Subject: Response to Request for Additional Information Regarding Licensing Amendment Request to Revise Technical Specifications (TS) Surveillance Requirements and TS Table for Mathematical Symbols and Use of Allowable Values in the Place of Analytical Limits
Cooper Nuclear Station, Docket 50-298, DPR-46

**Response to Request for Additional Information Regarding Licensing Amendment Request
to Revise Technical Specifications (TS) Surveillance Requirements and TS Table for
Mathematical Symbols and Use of Allowable Values in the Place of Analytical Limits**

**Cooper Nuclear Station
Docket 50-298, DPR-46**

Figure 1, Rod Block Monitor operating regions showing associated setpoint values.

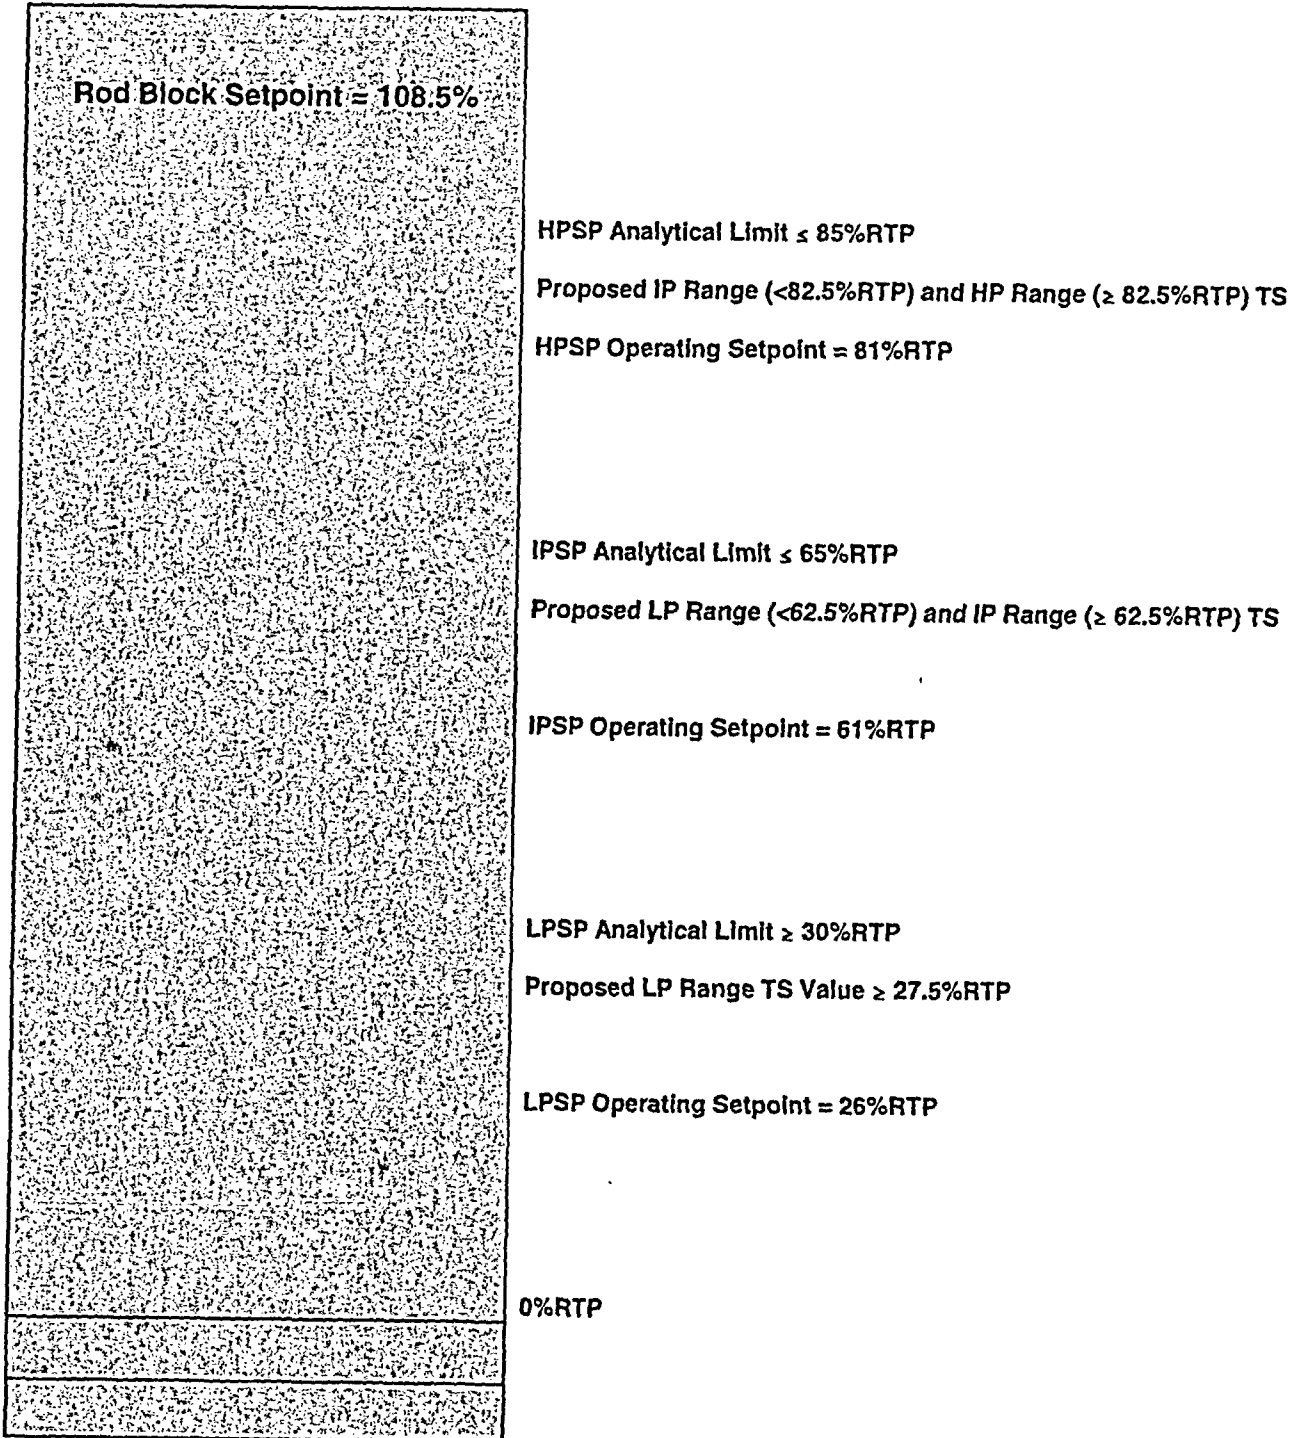
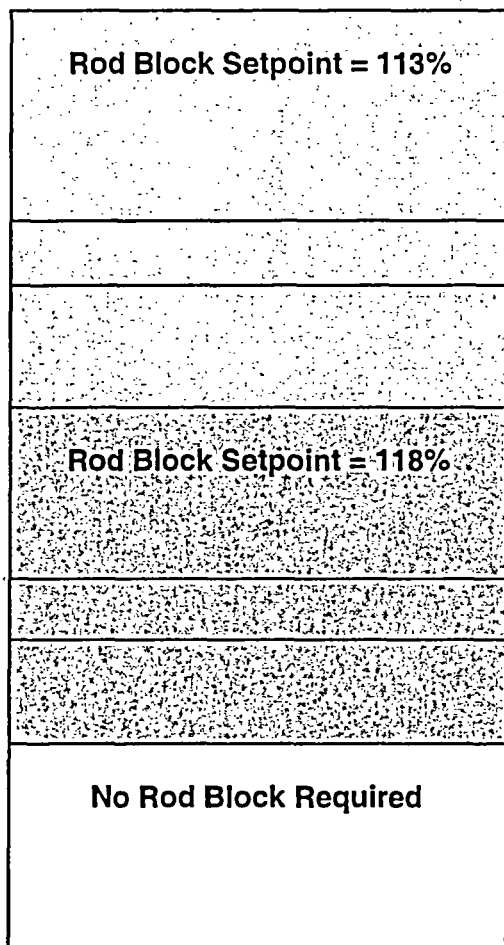
The Technical Specification (TS), Table 3.3.2.1-1 and associated TS Bases, define several separate "zones" of percent rated thermal power (%RTP) and minimum critical power ratio (MCPR), in which various trip functions are enabled or suppressed. The functional zones are defined by Conditions a, b, c and d. Condition e overlaps Conditions a, b and c. The associated TS Bases define "no-trip" zones (i.e., zones not requiring any trip function) at power levels below 30 percent for all MCPRs, at all power levels for MCPRs of 1.7 or greater, and at power levels above 90% for MCPR greater than or equal to 1.4. The proposed Allowable Values (AVs) protect against errors in determining which zone is in effect at any given time. The margin applied to the 30 percent limit ensures that an underestimation of thermal power when operating just above 30 percent will tend to result in the application of the Condition a setpoints rather than in the assumption of "low power no-trip" zone and the suppression of all trips. This is clearly conservative. But it is not clear whether Condition a setpoints or Condition b setpoints are more conservative for thermal power estimation errors when operating near 65 percent. Similarly, for Condition b and c near 85 percent. The inverse relationship of setpoint to power regime further confuses this matter (the low power trip setpoints are higher than the high power trip setpoints). In addition, the "high power no-trip" zone for power greater than or equal to 90 percent with MCPR greater than or equal to 1.4 seems to indicate, counter intuitively, that operation is safer above 90 percent than below 90 percent.

For all RBM Functions in TS Table 3.3.2.1-1 and for the "no-trip" zones in the TS Bases for the RBM (B3.3.2.1, page B3.3-45), please indicate whether overestimation or underestimation of thermal power is more conservative and provide the reasoning behind each determination. Show that the proposed margins are on the correct side (i.e., where the margins produce, rather than detract from, conservatism) of each zone boundary. Explain why no margin is needed at the 90 percent power level.

Please refer to the graph on the following page along with the following explanation. The way that the setpoints for the various regions were determined has not changed from when Cooper converted from flow-biased RBM setpoints to the current three zone method. Instrument uncertainties are deducted from the Analytical Limit (AL) to determine the Allowable Value (AV) and Nominal Trip Setpoint (NTSP), per GE Setpoint Methodology. Additional tests are then applied to the NTSP (i.e. LER Avoidance, Required Limits Evaluation) and a final operating setpoint determined. In the case for the transition from the 'No Rod Block Required' region less than 30% RTP to the low power (LP) region, the conservative situation is to have the rod block in effect prior to reaching 30%, so the calculated AV is 27.5% and the setpoint is 26%. As mentioned, clearly this is conservative. For the transition from the low power setpoint (LPSP) to the intermediate power setpoint (IPSP) and the IPSP to high power setpoint (HPSP), the same calculational methodology was used, i.e. deducted instrument uncertainties from the AL to determine the AV and NTSP. In those two cases, it is conservative to have the transition region below the AL (and also below the AV) and use the rod block setpoint of the "higher region." Specifically, when moving from the LP region to the IP region, the rod block setpoint will shift from 118% down to 113% at 61% RTP, even though the rod block setpoint could be 118% up to the AV of 62.5% RTP. The same discussion holds for the transition from the IP region to the HP region. Additionally, an underestimation of thermal power when operating just above the AL will still result in a shift to the next higher region's rod block setpoint before reaching the AL, while an overestimation of thermal power will cause a shift to the next higher region at some point below the AL, both of which are more limiting.

The calculation Conclusion Section lists a set of permissible rod block values for AL, AV and Operating Setpoint, based on different MCPR Limits. From USAR Section XIV-7, Table XIV-7-2, the MCPR Limit for Rod Withdrawal Error for the current fuel cycle is 1.32. Therefore, the setpoints for the various regions were selected based on a MCPR Limit of 1.30, which yields the lower rod block setpoints.

The proposed change to the "algebraic signs" in SR 3.3.2.1.4 and Table 3.3.2.1-1 (Notes) is based on our determination that it is conservative to ensure that the rod block setpoint for the next higher region is in effect prior to the AL because that rod block setpoint is a lower value, and thus more limiting.

Even though the Rod Block Monitor function is not required above 90% when MCPR is greater than 1.4, there is no bypass for this region. The only conditions that will automatically bypass the RBM is operation below the Low Power Setpoint (analytical limit of 30%RTP) or a peripheral control rod selected for movement. Therefore, there is

no "high power no-trip" zone and no need to calculate a margin for this value.
